**Wichita-Sedgwick County
Metropolitan Area
Planning Department**

Re: **BZA2024-00065:** Administrative Adjustment in the City to reduce the street side setback from 15 feet to 12 feet (20 percent) to construct a single-family dwelling on property zoned SF-5 Single-Family Residential District, generally located within one-half mile east of South Seneca Street and within one-half mile north of West 47th Street South (4502 S. Sycamore).

Legal Description: Lot 1, Block 13, Purcell's 10th Addition, Wichita, Sedgwick County, Kansas.

Site Plan — Administrative Adjustment
 4502 S. Sycamore
 House Plan: The Angel
 Lot 1, Blk 13, Purcell's 10th
 Builder: Titan Builders, LLC
 Angel Moreno

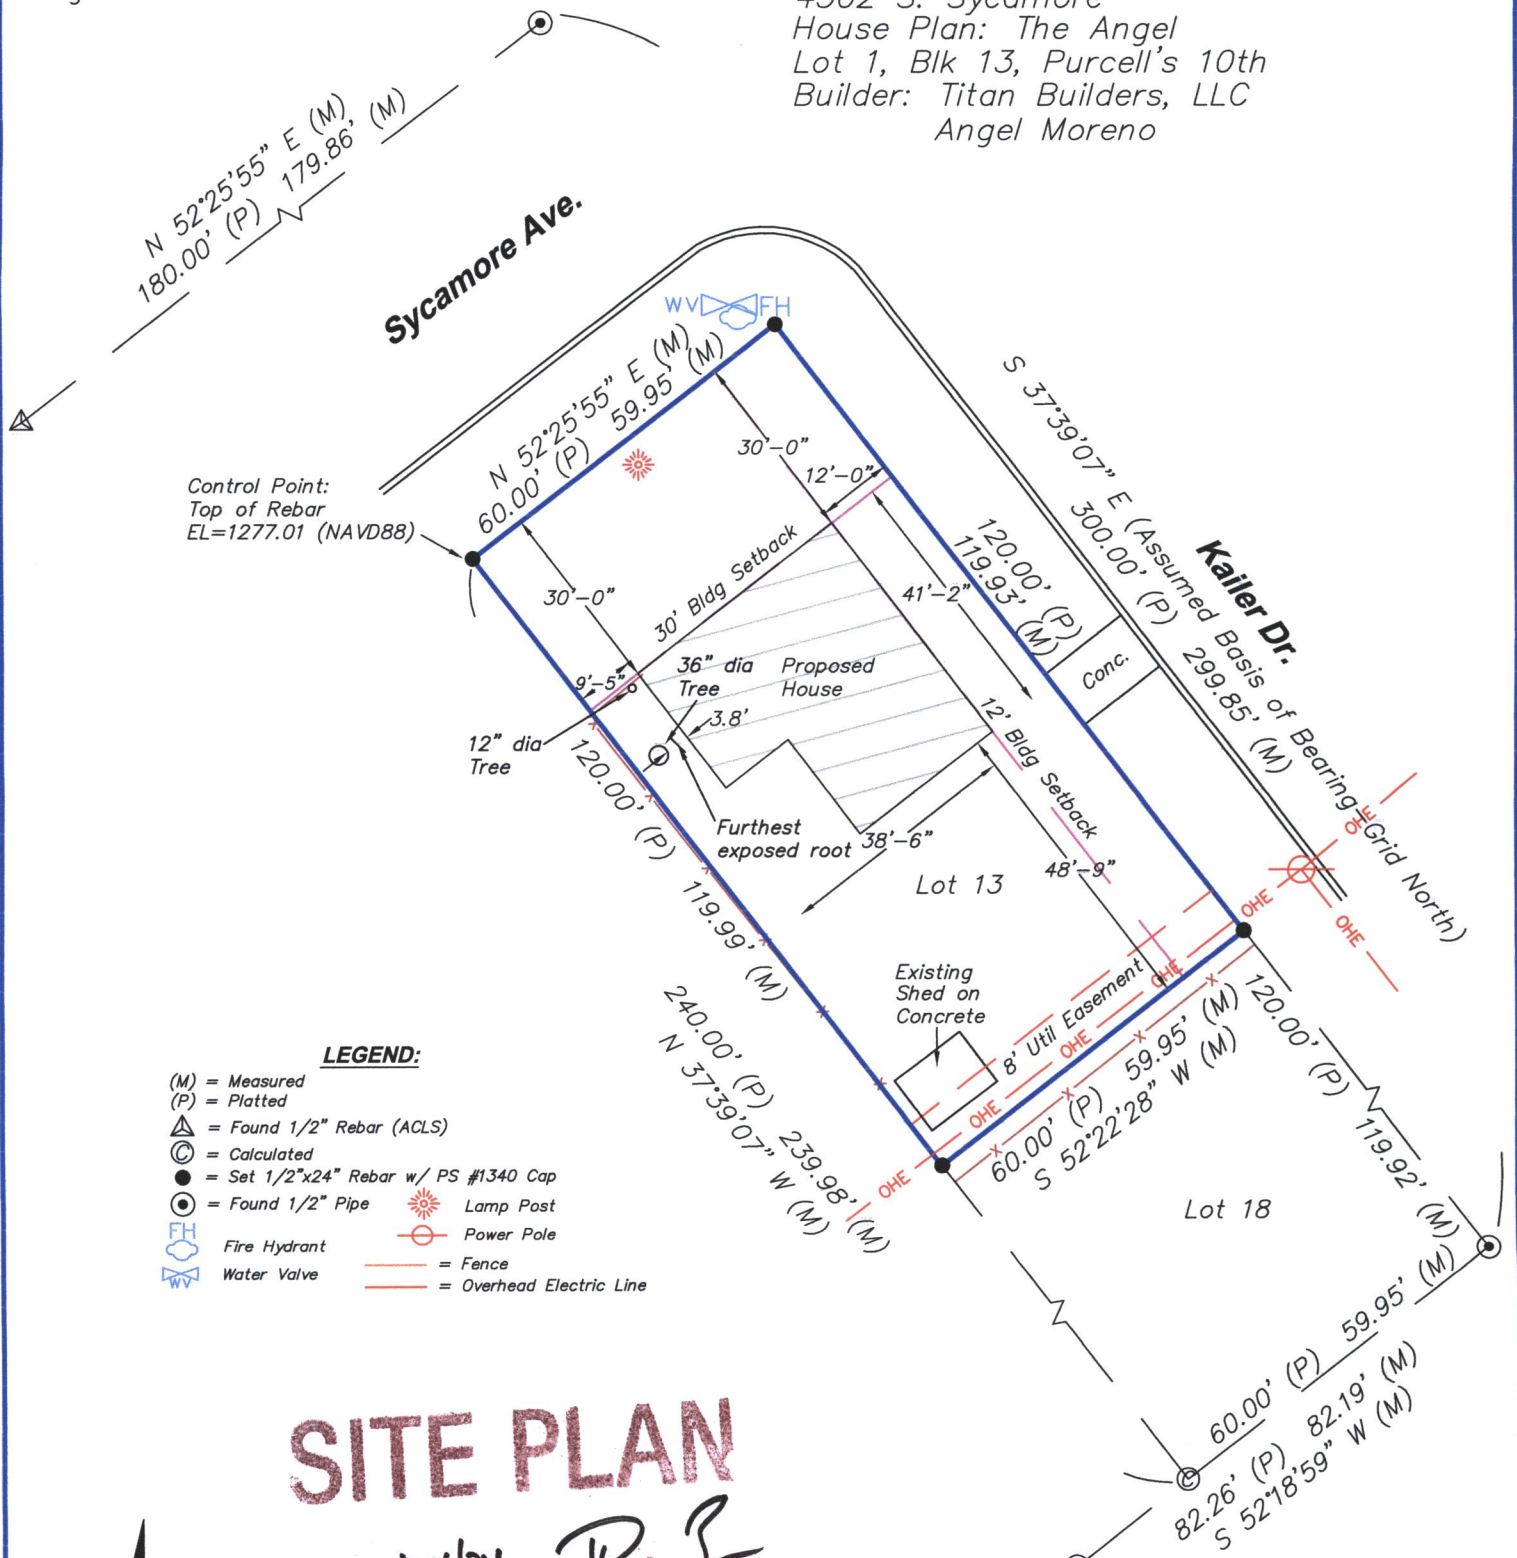
- 1) The existing shed that is shown to be encroaching into the 8-foot utility easement shall be relocated out of the utility easement, and the site plan shall be revised accordingly, prior to the issuance of building permits.

- 4) The setback reduction shall apply only to the 12-foot street side setback for a dwelling as illustrated on the approved site plan. All other structures or additions on the subject properties shall conform to the setbacks permitted by the Unified Zoning Code unless a separate Zoning Adjustment or Variance is granted.
